State of North Carolina
Department of Environment,
Health and Natural Resources
Division of Solid Waste Management

RE: Upgrade of Detection Monitoring System
Closed Madison County Sanitary Landfill
Permit #58-02

RE: Hydrogeologic Review Of The Water Quality Monitoring Plan Of
The Transition Plan For The Madison County Landfill, # 58-03

MW-1

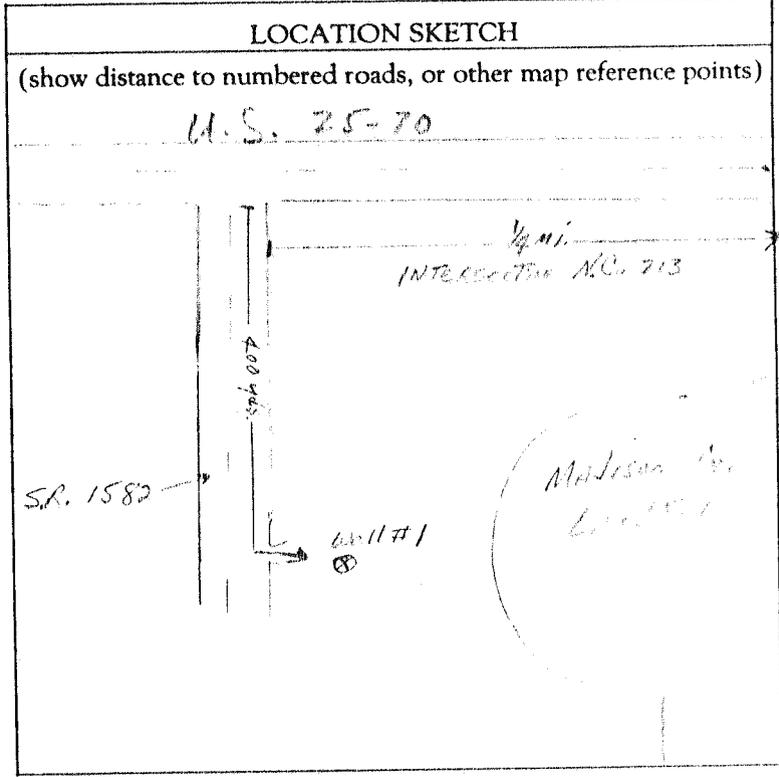
Before a final closure letter for the landfill can be issued, Madison County will need to replace MW-1 and MW-2 with new wells at the same locations. These need to be installed with 15-foot screens, with the tops of the screens set just above the seasonal high water table, unless hydrogeologic conditions justify changes from this design.
